MEMO

DATE: March 7, 2017
TO: Jonathan Pearlman
FROM: Joshua Switzky, Planning Department
RE: PPA Case No. 2016-015814PPA for 5400 Geary Boulevard

Preliminary Project Assessment

RE: **SDAT Review**
Case NO. 2016-015814PPA
Address: 5400 Geary Boulevard
Neighborhood: Inner Richmond
Zoning: NC-3 (Neighborhood Commercial, Moderate Scale)
Area Plan: None
Block/Lot: 1450/008

3. Geary frontage and Corner Bulbout at 18th Ave and Geary Blvd

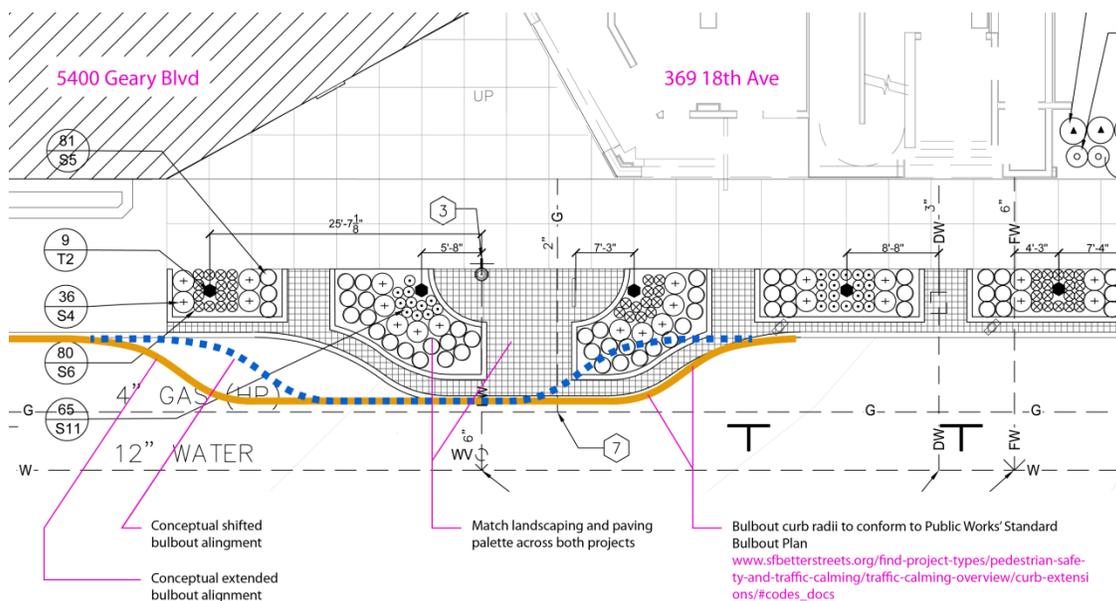
- The project's Geary frontage design shall be coordinated with the Geary BRT project in terms of furnishing, lighting, paving and planting pallets.
- The project sponsor should install a bulbout on the corner of Geary Boulevard and 18th Avenue. At minimum, the bulbout shall project 6 feet into the 18th Street ROW.

- The corner bulbout shall also project 6 feet into the Geary Blvd ROW *if it does not interfere with the Geary BRT project*. The project sponsor shall work with SFMTA to determine the feasibility and dimensions of the bulbout. Please contact Dan Mackowski (Daniel.Mackowski@sfmta.com) for coordination with the SFMTA's Geary BRT project.

- Per guidelines established in the San Francisco Better Streets Plan the tangent of the curb return on a corner bulbout should start a minimum of 5' beyond the property line.

- To ensure that bulbouts are sweepable with standard City street sweeper equipment, bulbout curb returns shall conform to SF Public Works' Standard Plan for Curb Bulbs. See: http://www.sfbetterstreets.org/find-project-types/pedestrian-safety-and-traffic-calming/traffic-calming-overview/curb-extensions/#codes_docs

Geary frontage and Corner Bulbout at 18th Ave and Geary Blvd

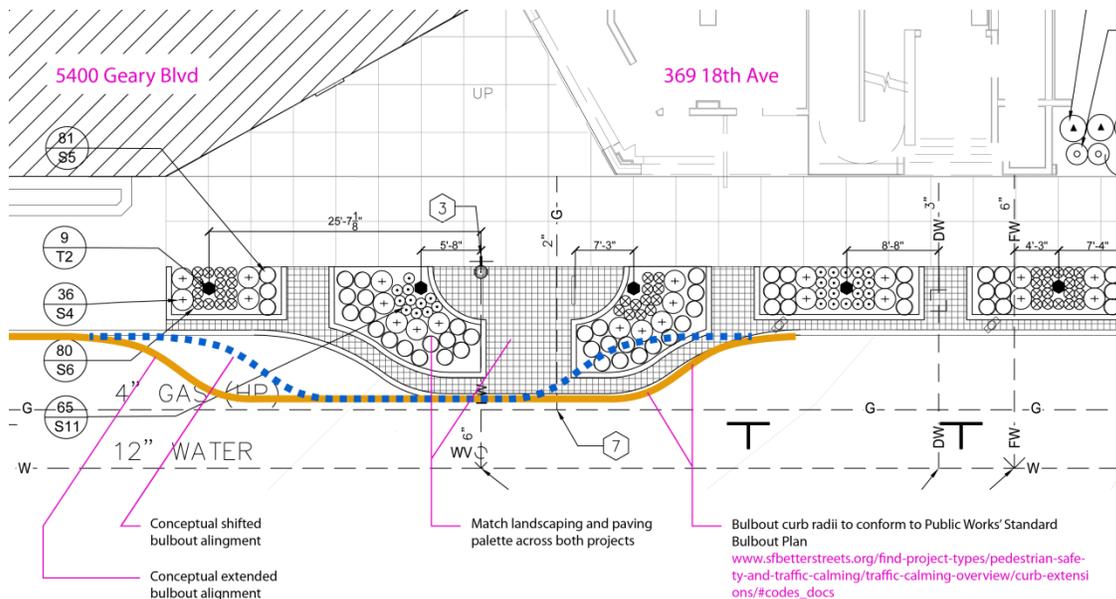
- The project's Geary frontage design shall be coordinated with the Geary BRT project in terms of furnishing, lighting, paving and planting pallets.

- The project sponsor should install a bulbout on the corner of Geary Boulevard and 18th Avenue. At minimum, the bulbout shall project 6 feet into the 18th Street ROW.

- Per guidelines established in the San Francisco Better Streets Plan the tangent of the curb return on a corner bulbout should start a minimum of 5' beyond the property line.

- To ensure that bulbouts are sweepable with standard City street sweeper equipment, bulbout curb returns shall conform to SF Public Works' Standard Plan for Curb Bulbs. See: http://www.sfbetterstreets.org/find-project-types/pedestrian-safety-and-traffic-calming/traffic-calming-overview/curb-extensions/#codes_docs
